ADDENDUM NO. 1

ISSUE DATE: April 4, 2018

CRC College Center Expansion

LRCCD BID NO. 17021

SHEET NO:
A8.34

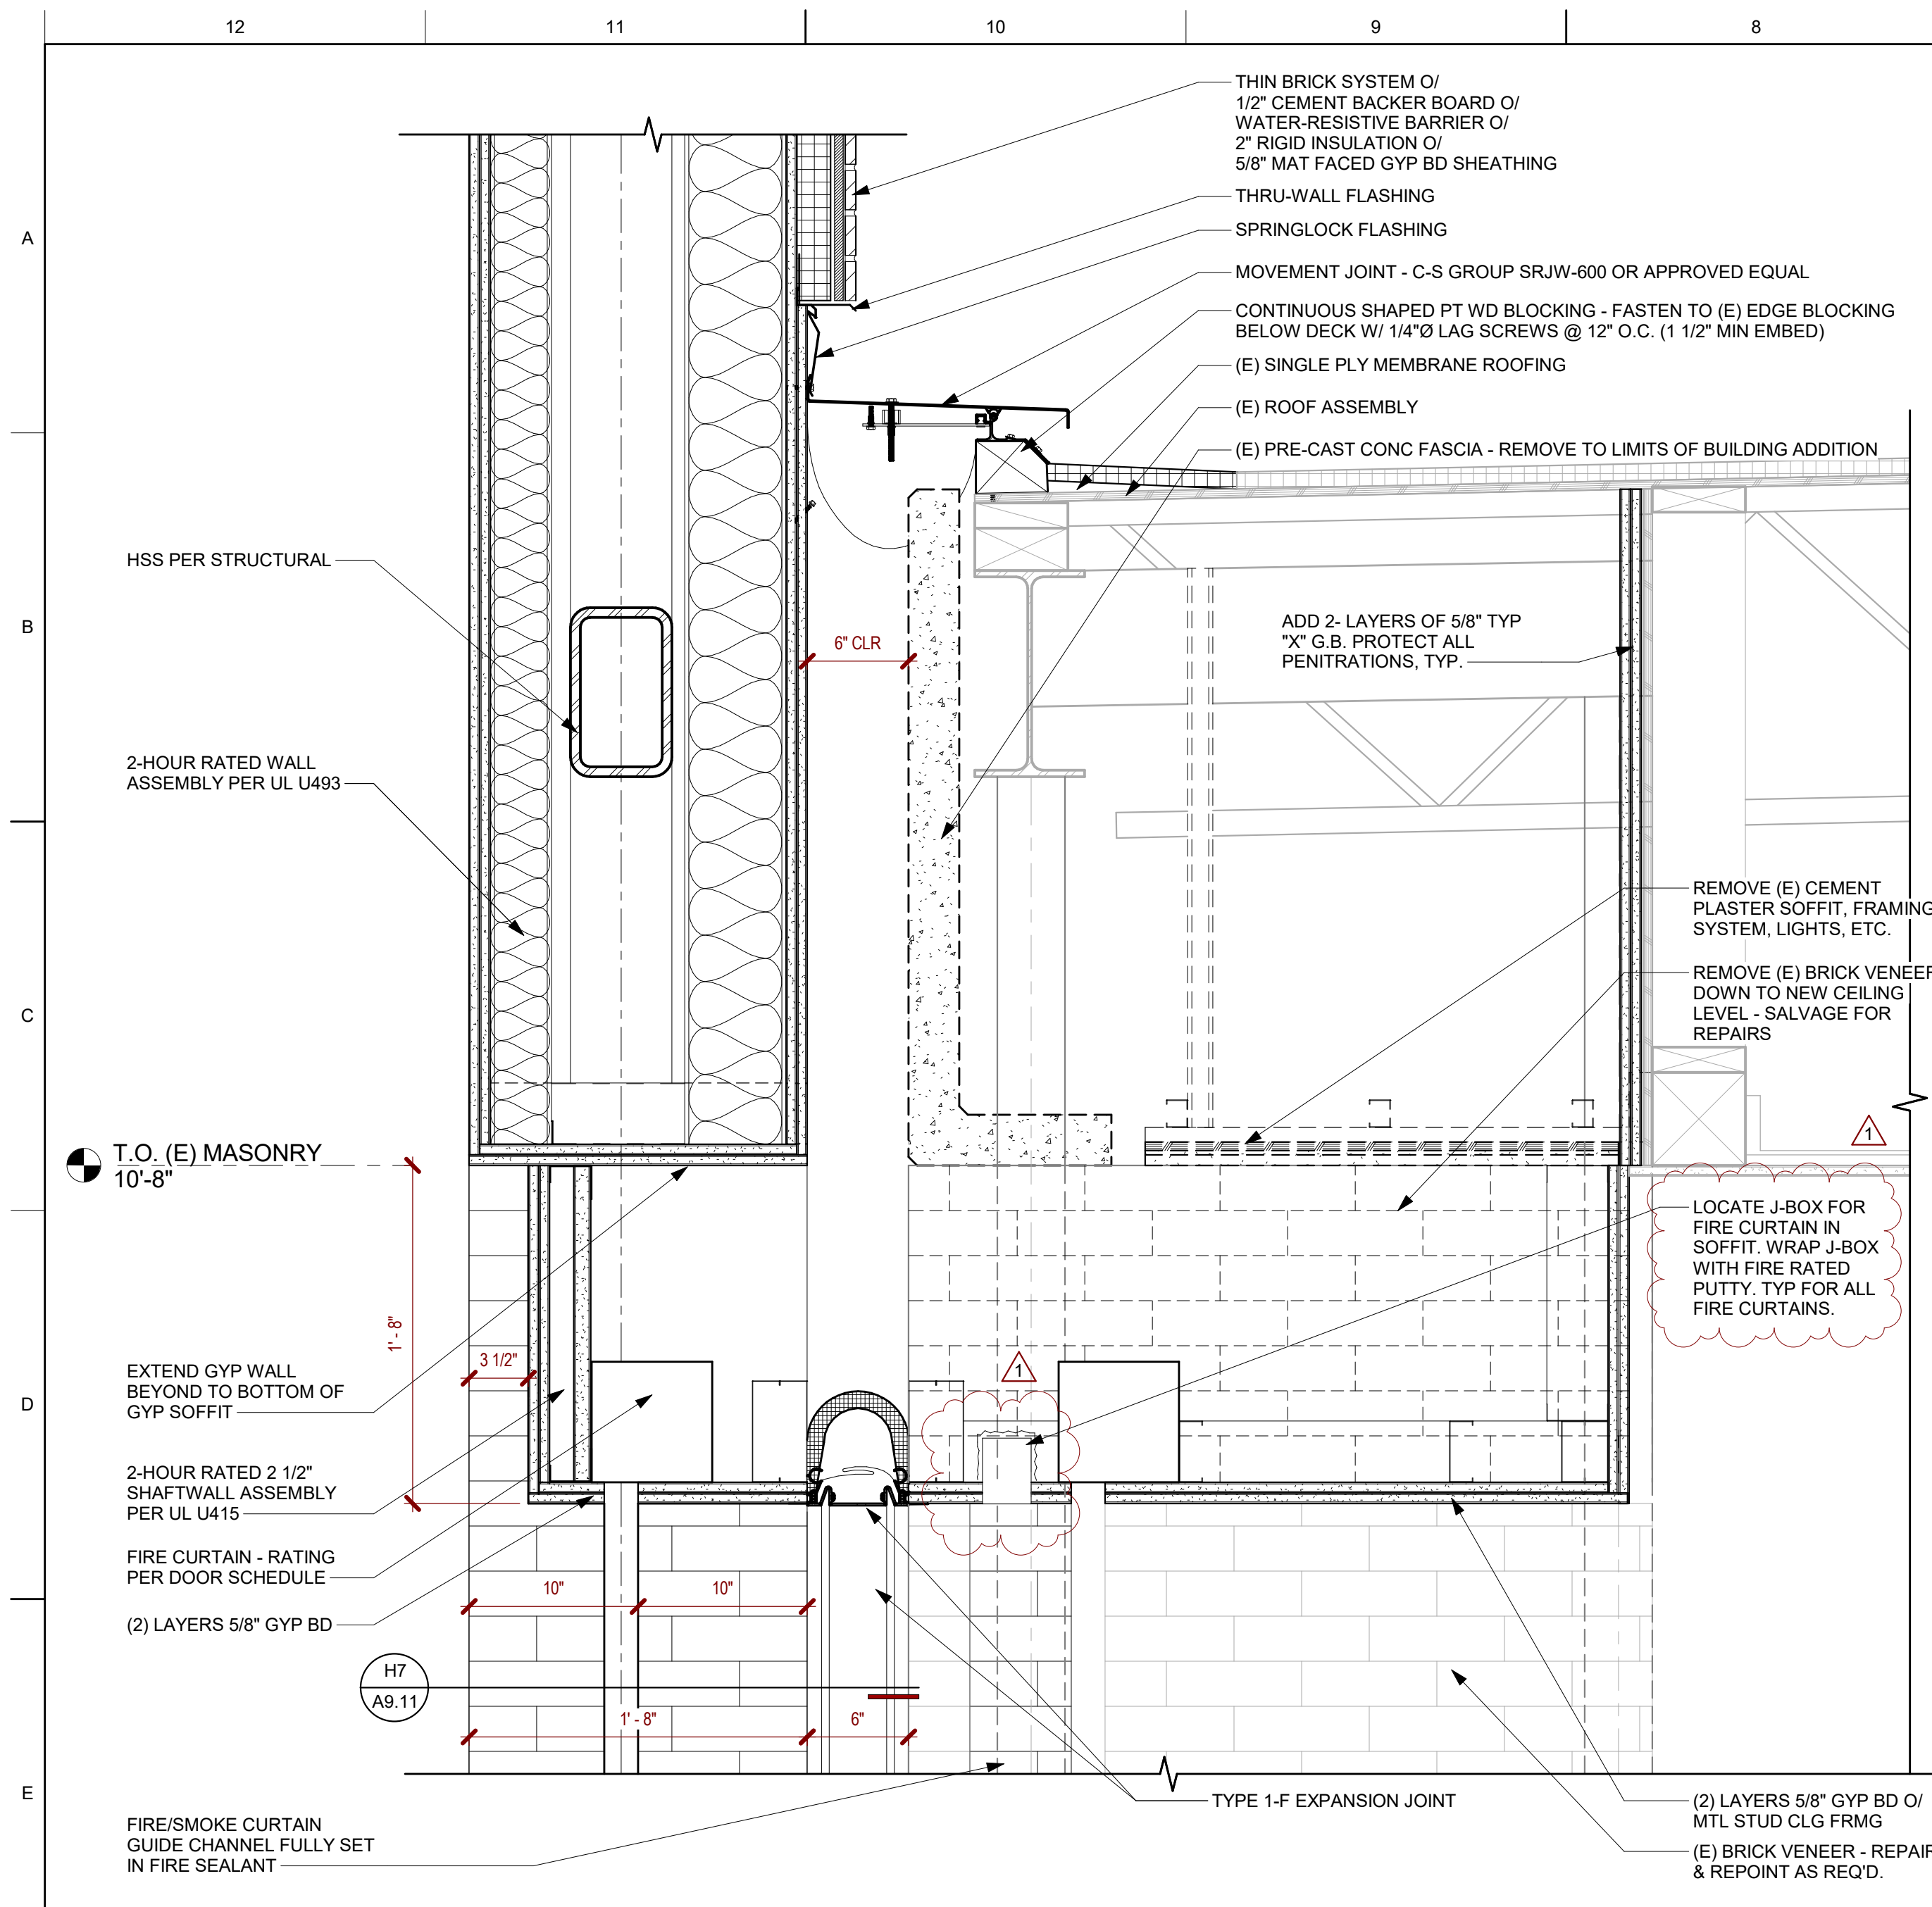
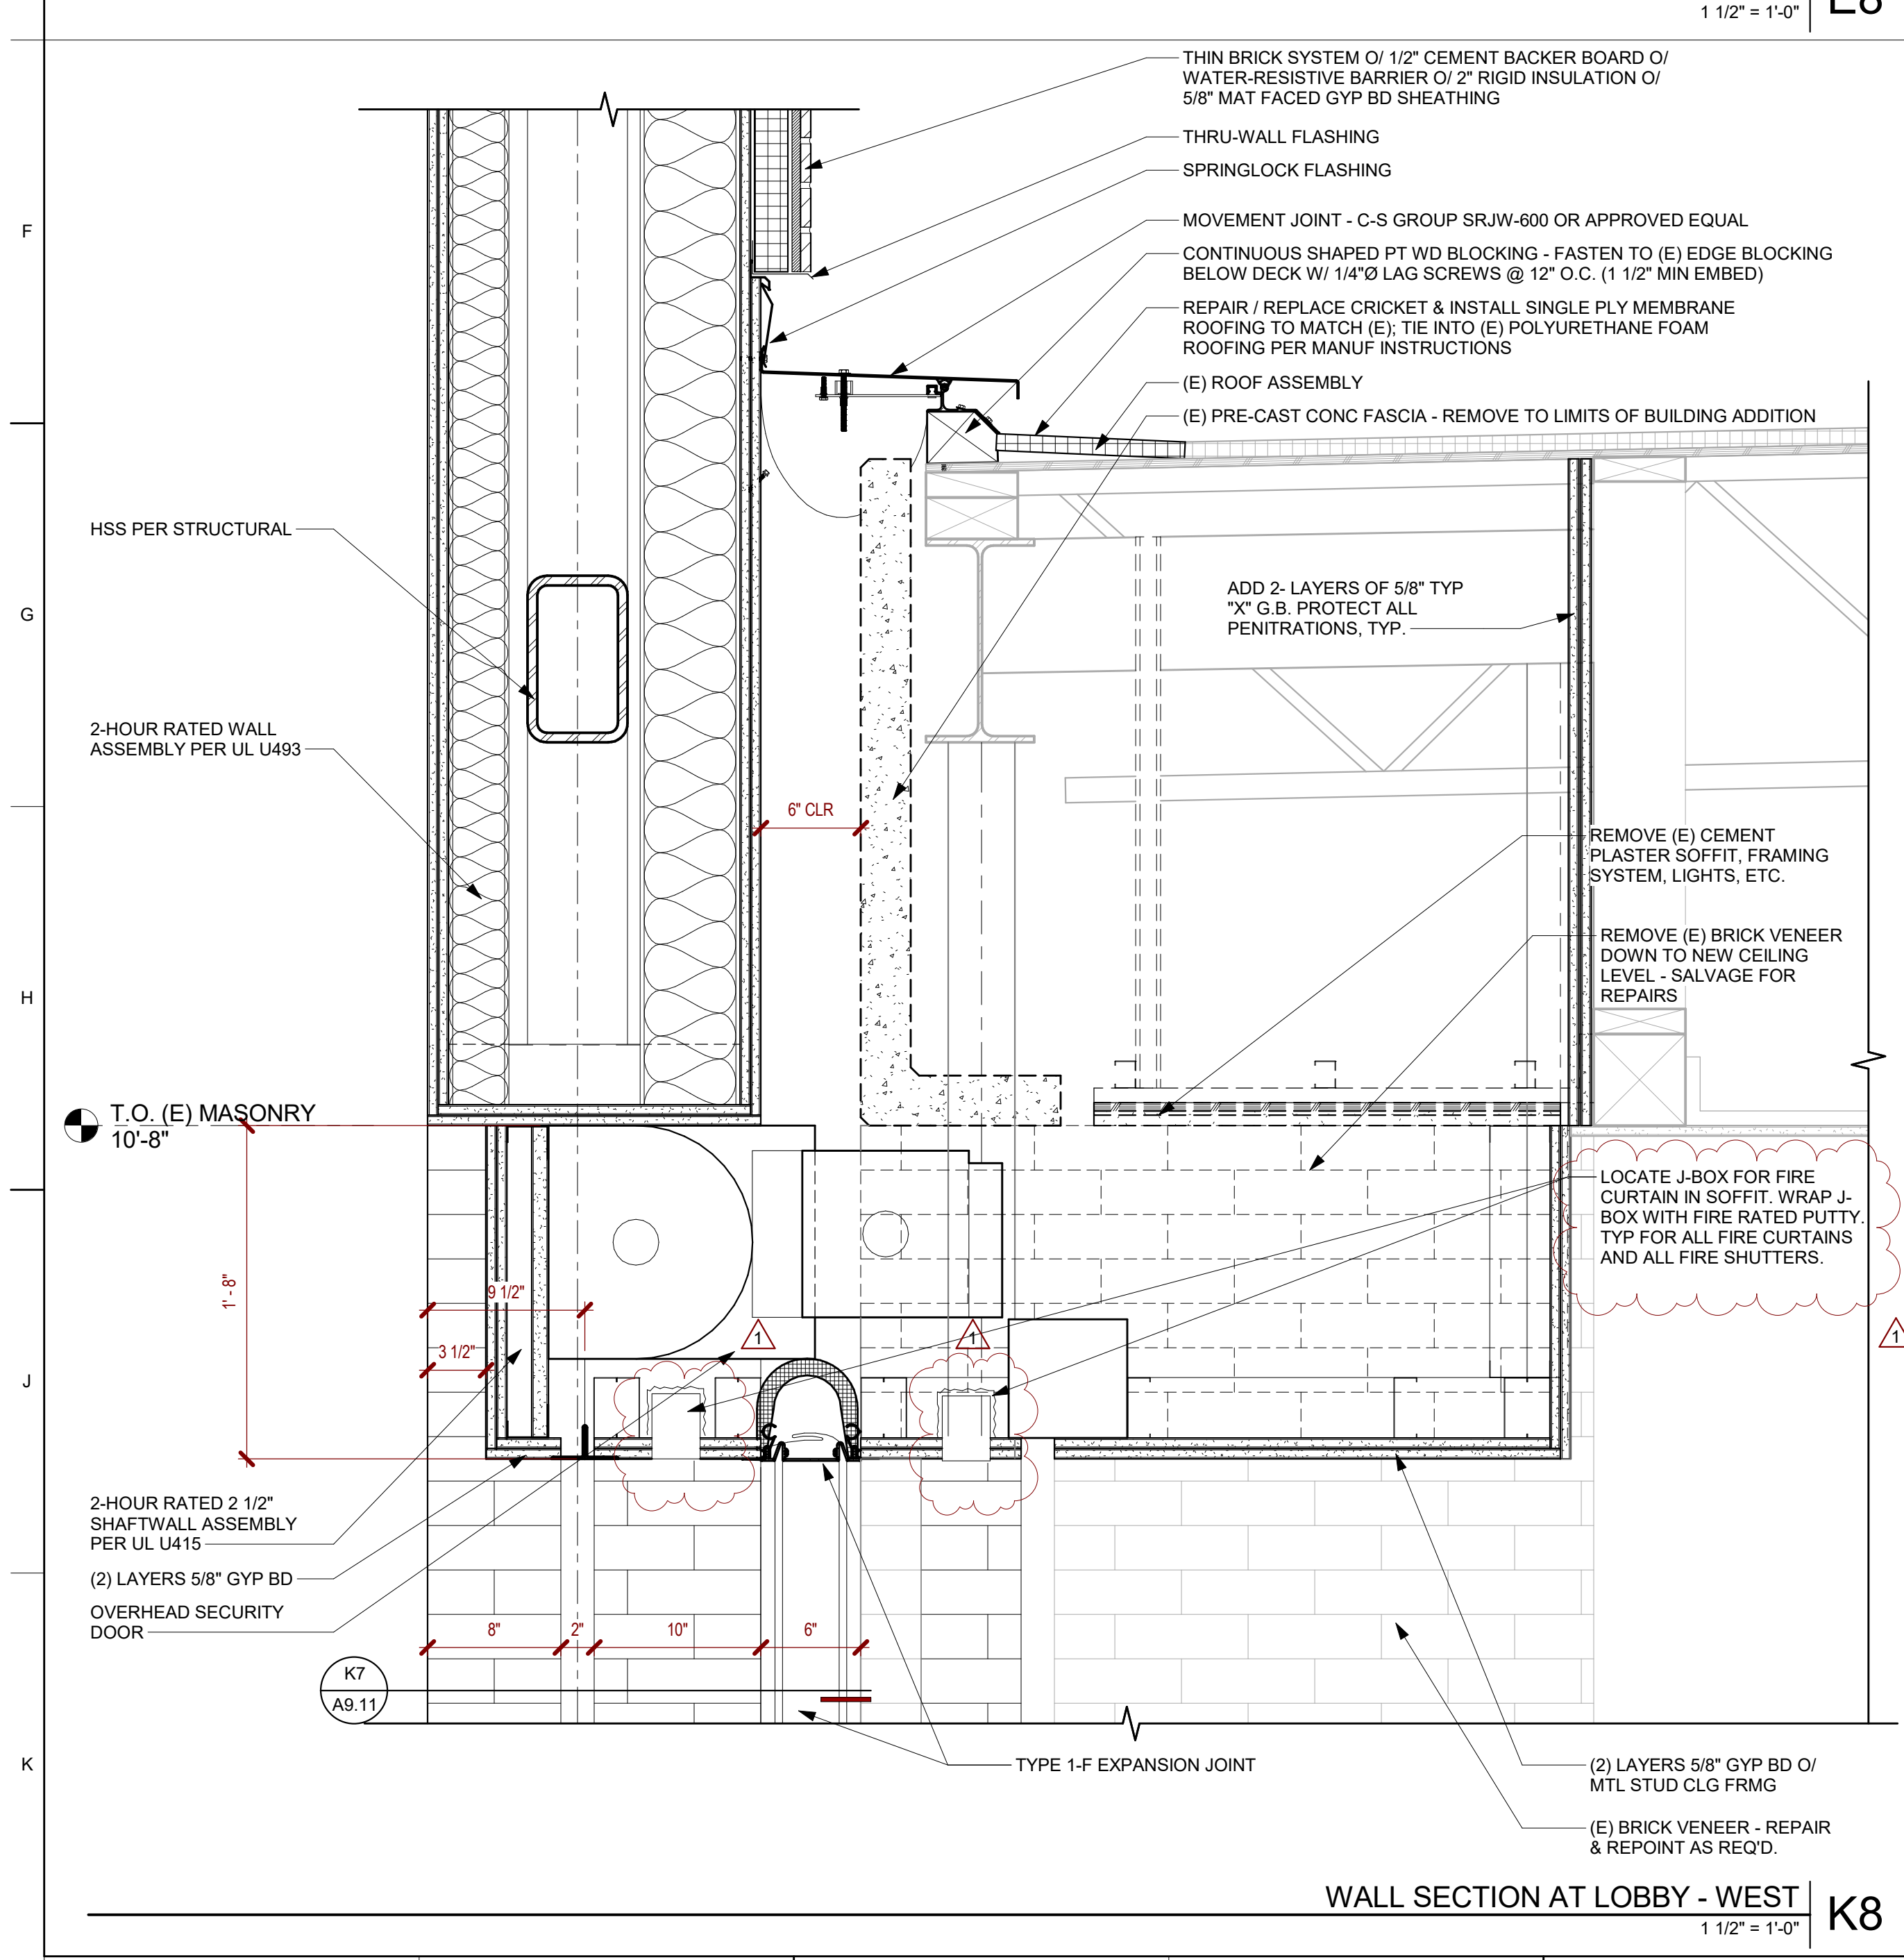
- A8.34 – Added detail G4
- A9.10 – Modified detail K8 and E8
- A9.11 – Modified detail F10 & H5. Removed detail F5
- A9.12 – Modified detail H3, H6, F8, F10, D8 and D10
